PRELIMINARY PLAN OF WINDSOR PARK
PROPERTY OF G. G. FRALIN
BEING TRACT NO. 2, 19.39 ACRES ±, PARTITION OF GEO. GARST SR. ESTATE
SHOWING PROPOSED STREET & LOT LAYOUT, ST. GRADES & SEWER
SITUATE NORTH OF GRANDIN ROAD, WEST OF MUD LICK CREEK
ADJOINING THE WEST CORP. LIMIT OF ROANOKE CITY,
ROANOKE COUNTY, VIRGINIA.
BY: C. B. MALCOLM & SON
VA. STATE CERT. ENGRS.
N.B. 815-1952
DATE: APR. 16, 1953
PLAN SCALE: 1"=100'

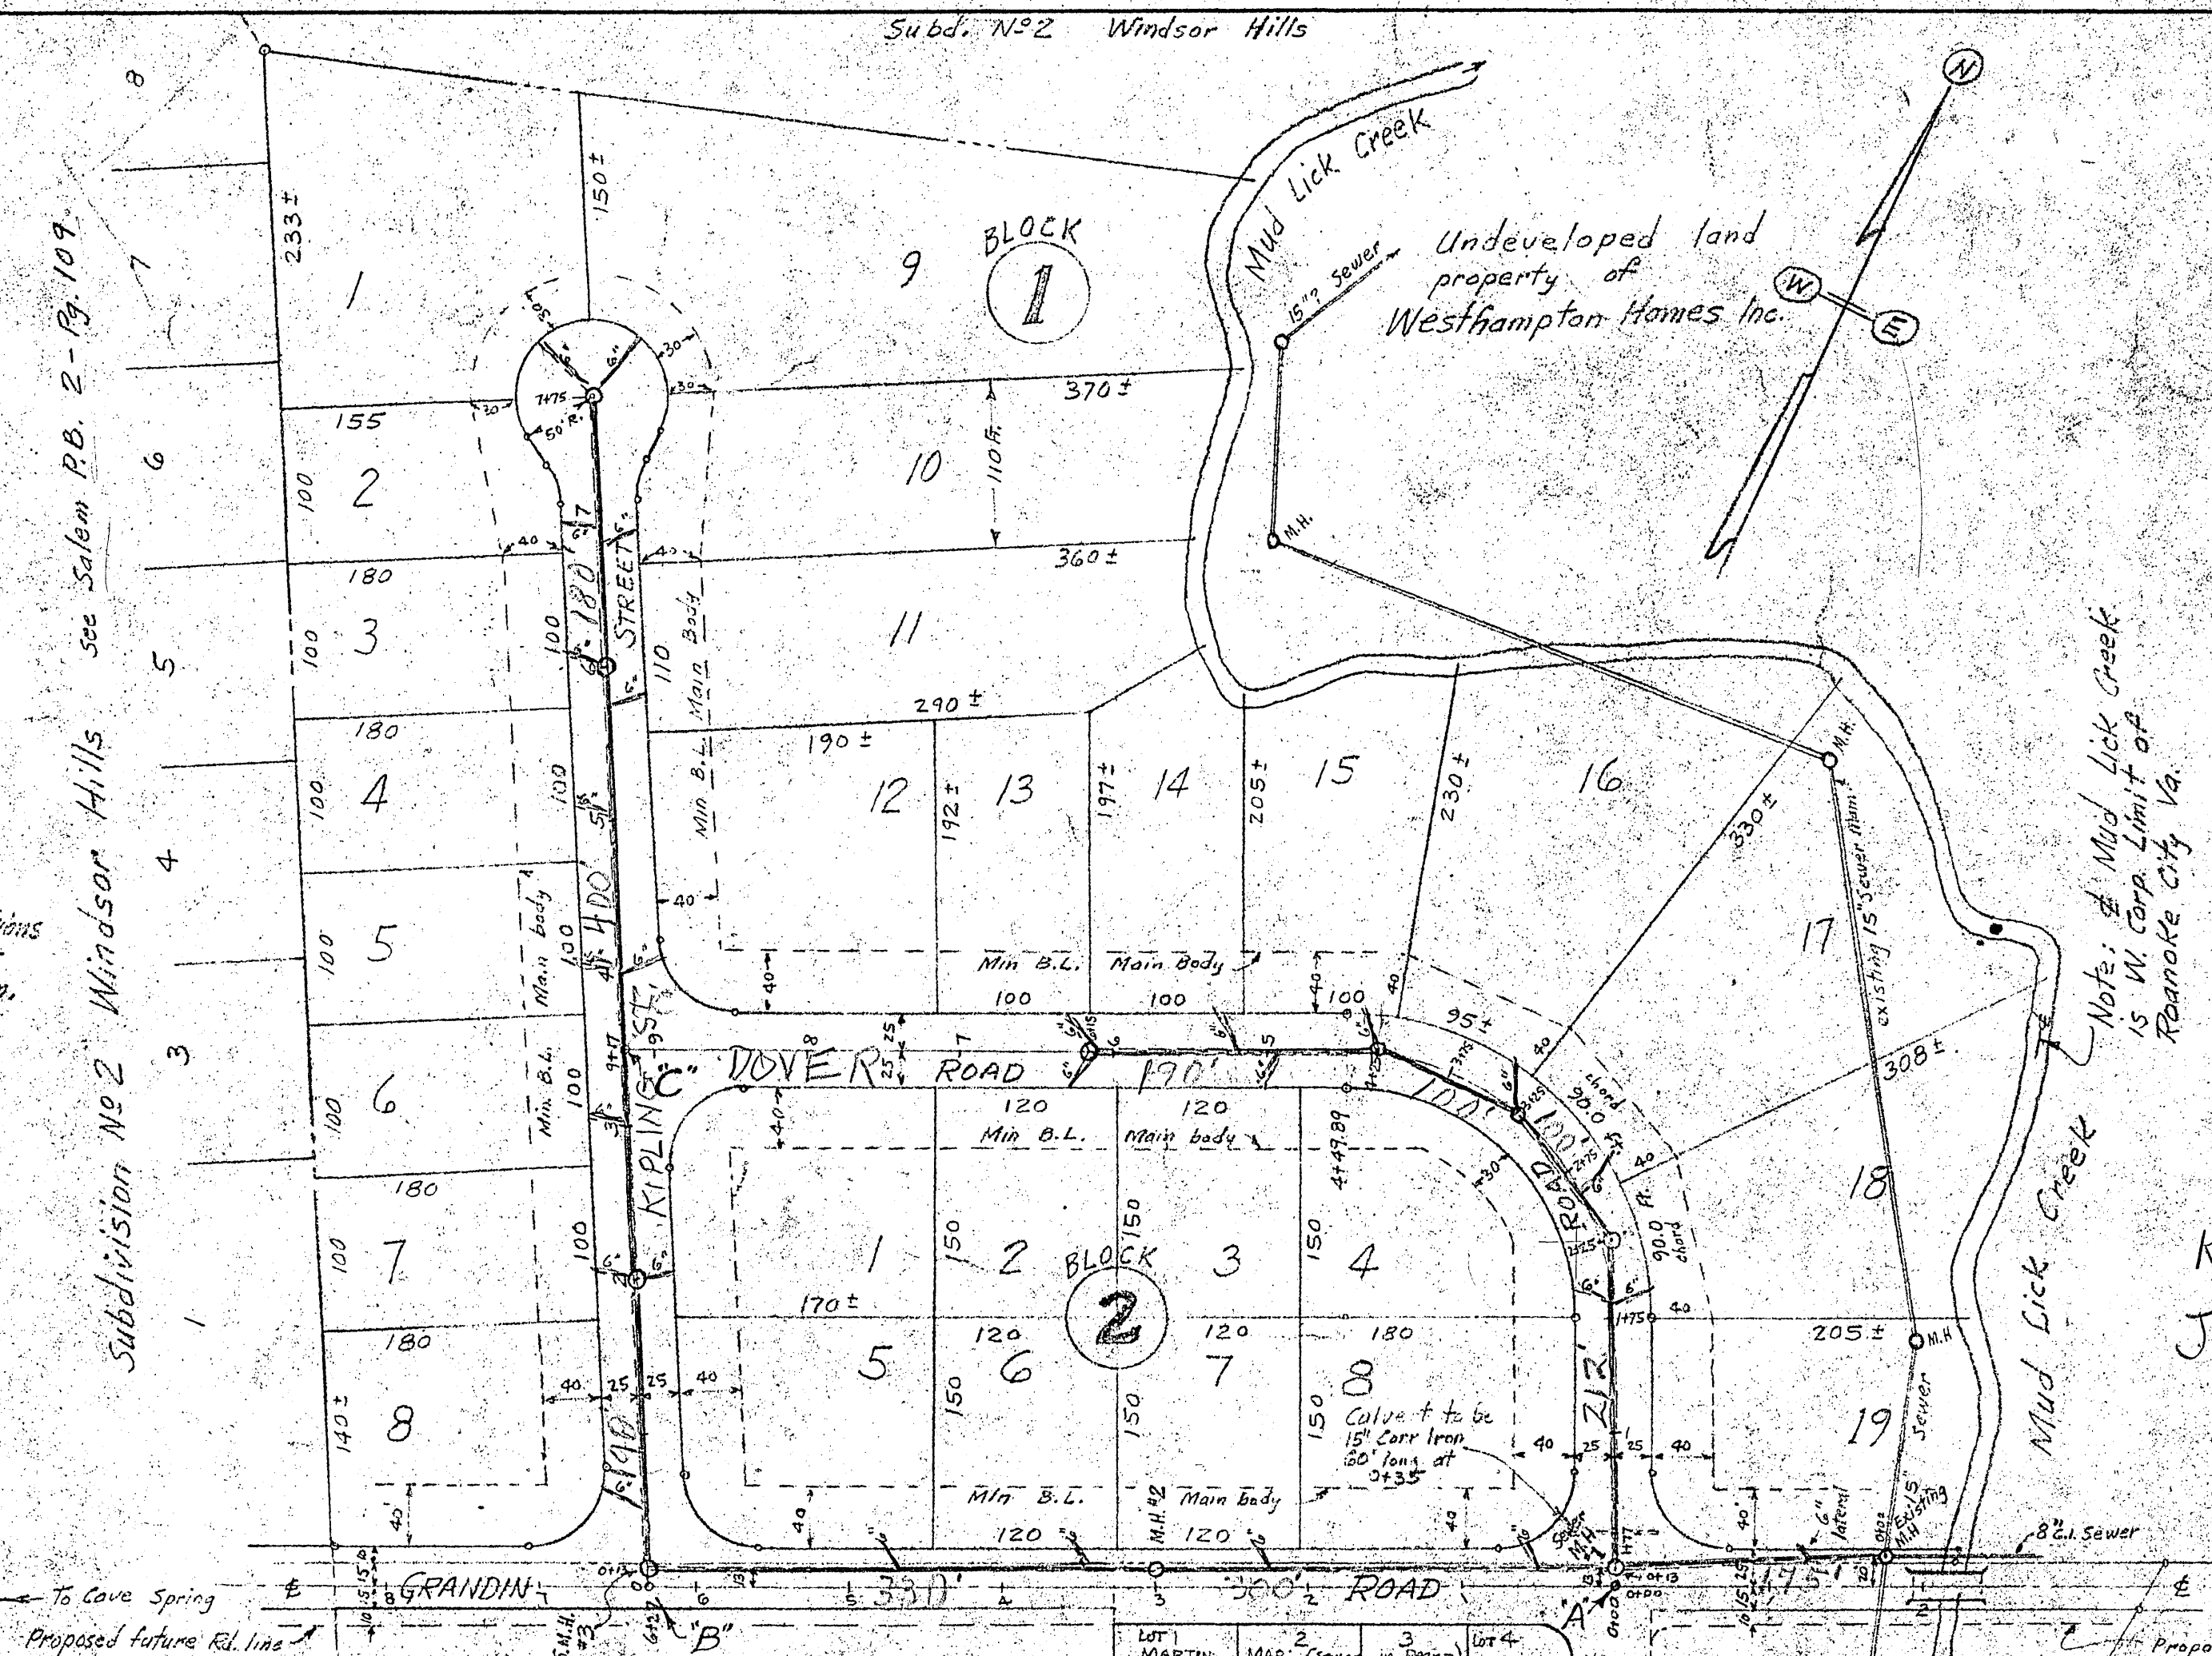
Subdivision Name? Street Names?
Subdivision No. 3, Windsor Hills?
